802.3dj D1.0
Comment Resolution - Electrical track
Adee Ran, Cisco

Introduction

Figure 176E–2—Components of a 200 Gb/s per lane AUI-C2M interface and insertion loss budget at 53.125 GHz

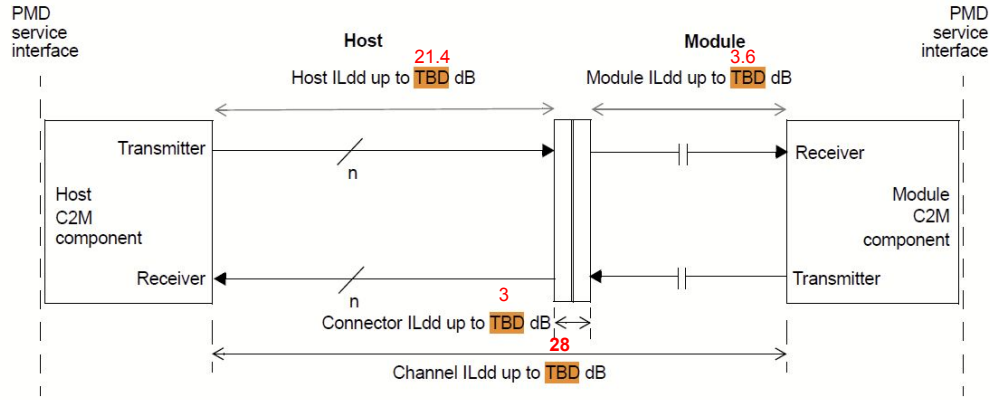
CI 176E SC 176E.2 P615 L33 # 130
 Ghiasi, Ali Ghiasi Quantum/Marvell
 Comment Type T Comment Status X
 Loss budgets are TBD
 SuggestedRemedy
 See Ghiasi C2M May-24 Contribution for background on the numbers
 IIDD=28 dB
 Connector with one via = 3 dB
 Module Ildd = 3.6 dB
 Host Ildd=21.4 dB
 Proposed Response Response Status O

CI 176E SC 176E.4.1 P632 L6 # 73
 Lusted, Kent Intel Corporation
 Comment Type TR Comment Status X
 The IL_dd for AUI C2M channel is a TBD
 SuggestedRemedy
 Set IL_dd = 33 per https://www.ieee802.org/3/dj/public/24_01/lusted_3dj_03_2401.pdf
 Proposed Response Response Status O

The referenced presentation https://www.ieee802.org/3/dj/public/24_05/lusted_3dj_03_2405.pdf does not address ILdd. The comment is against 176E.4.1 (Recommended channel characteristics/Insertion loss), which has an equation for the ILdd limit. The suggested remedy does not address the equation. The proposed Channel ILdd value is 33 dB.
